### New Service Housing Assembly for all Drum Brake 2430XL & 2030XL Spring Brakes

L55320W US 9/10 WEB ONLY

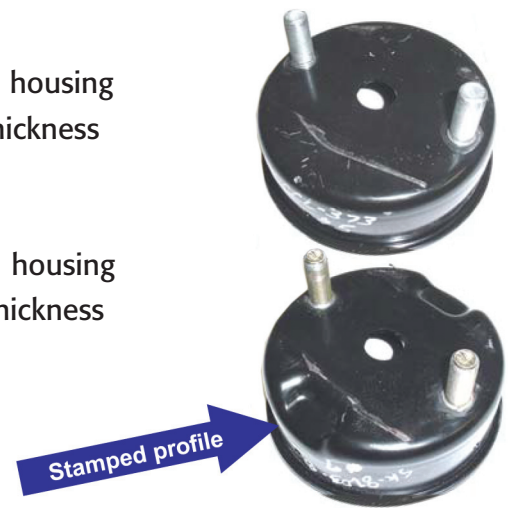
Starting in November 2010 all 76mm stroke Anchorlok® spring brakes will have a new stronger service housing. Part numbers that are affected by this change are shown in the table. The new service housing is thicker and has a distinctive stamped profile to increase rigidity. The new housing provides over 40% greater durability than the original product.

Original, flat bottom housing  
3.43mm (.135 in) thickness

New thicker shaped housing  
3.88mm (.149 in) thickness
